Park Street Triangle Traffic Study

Final Report

Subject: Final Report for Park Street Triangle Traffic Study

RESPONSES TO PUBLIC COMMENTS AND QUESTIONS AT THE COMMUNITY MEETING ON DECEMBER 1, 2005

Figure 5: 2004 Traffic Volumes at the Park Street Bridge

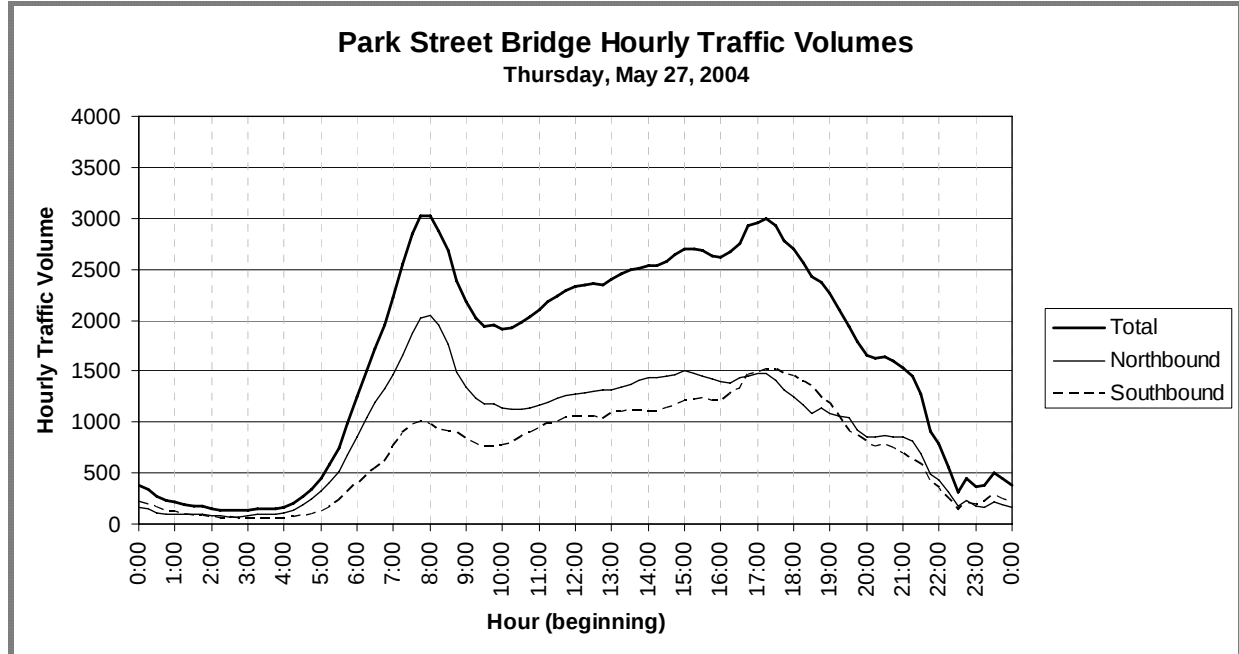
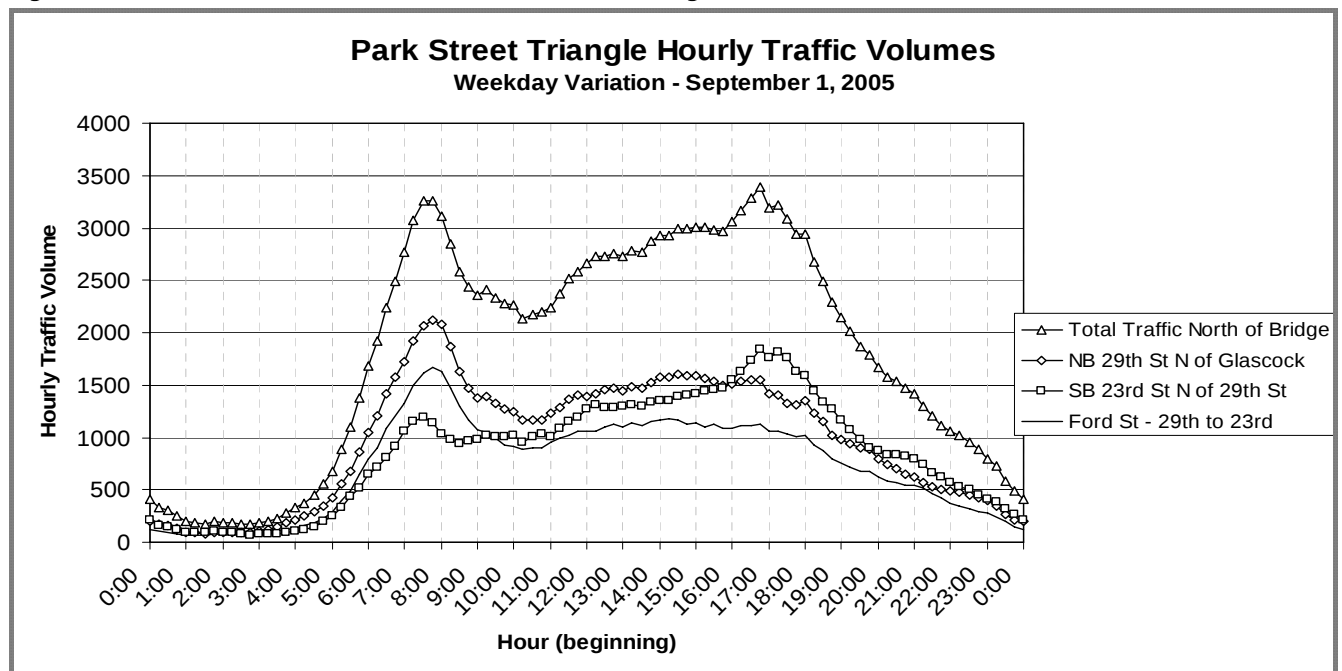
Response #4: Figures 5 and 6 are plots of 2004 and 2005 traffic volumes on the Park Street Bridge provided by the City of Alameda. This data is different from the average daily traffic (ADT) volume counts on 23rd Avenue and 29th Avenue collected as a part of the project (see Figure 1). Traffic counts collected at the four study intersections already account for local traffic that drive through these intersection but do not have an origin or destination in the City of Alameda.

Figure 14: Alternative 3 – Two-Way Operations on Existing Streets

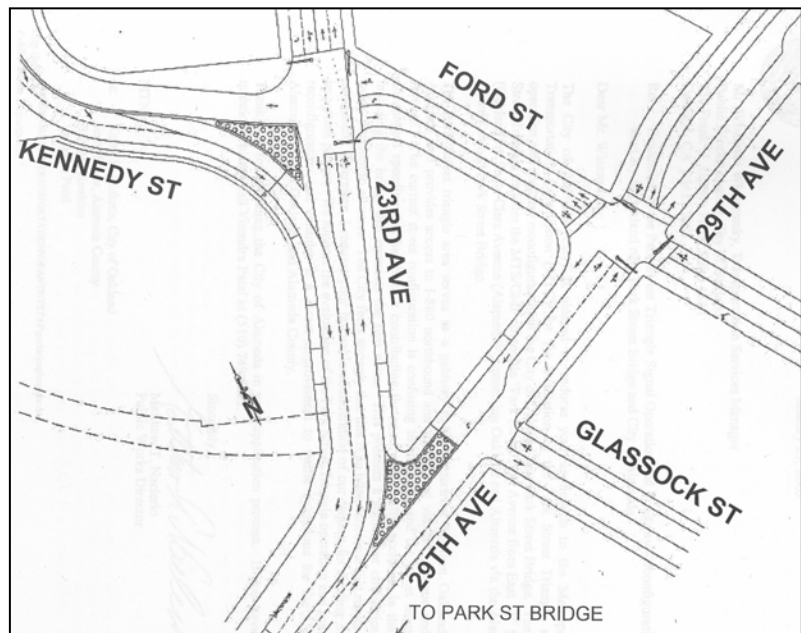
Comment/Question #4: Why don't you provide two left turn lanes and one right turn lane for vehicles exiting the bridge for Alternative 3?

Response #4: If three lanes are provided northbound coming off the Park Street Bridge and two of the lanes serve left turning vehicles and one lane serves right turning vehicles, there are likely to be erratic maneuvers by motorists approaching the location where the roadway splits. Motorists in the middle lane (who suddenly realize they should move to the right lane to proceed north on 29th Avenue) and motorists in the right lane (who suddenly realize they should move to the middle lane to proceed north on 23rd Avenue) may brake sharply or come to a stop to make lane changes. This conflict is likely to cause traffic congestion and reduce safety.

Figure 15
ALTERNATIVE 1.5 REFINED
23RD AVENUE CLOSURE

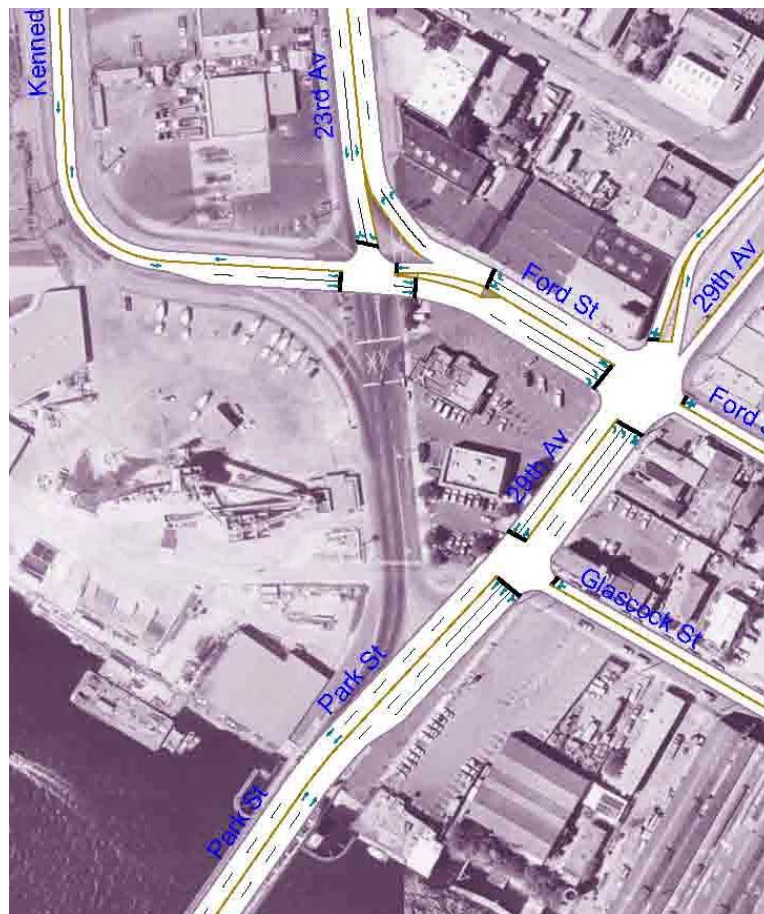
Comment/Question #34: Philip Ho: Under Alternative #1.5, the proposed multi-purpose trail crosses the RR track within the 29th/Glascock intersection at a very small angle of about 15 degrees. This is problematic for bikes, wheelchairs, and strollers. RR tracks are very smooth and slippery (especially in wet weather) compared to regular AC or rubberized AC surfaces. For safety reasons, crossings at RR tracks should ideally be at 90 degrees where possible. Let's discuss how we can resolve the trail alignment at the RR tracks.

Response #34: The location of the 29th Avenue Bay Trail crossing on the south side of the Glascock Street intersection would require cyclists and other wheeled vehicles on the trail to cross the railroad tracks at a very sharp angle. A crossing on the north side of the Glascock Street intersection would not require trail users to cross the tracks as they cross 29th Avenue but would require them to cross Glascock Street and cross the tracks at a right angle. This north crossing would be better for trail users but would require relocating the trail further to the north where the 7-Eleven store is currently located.
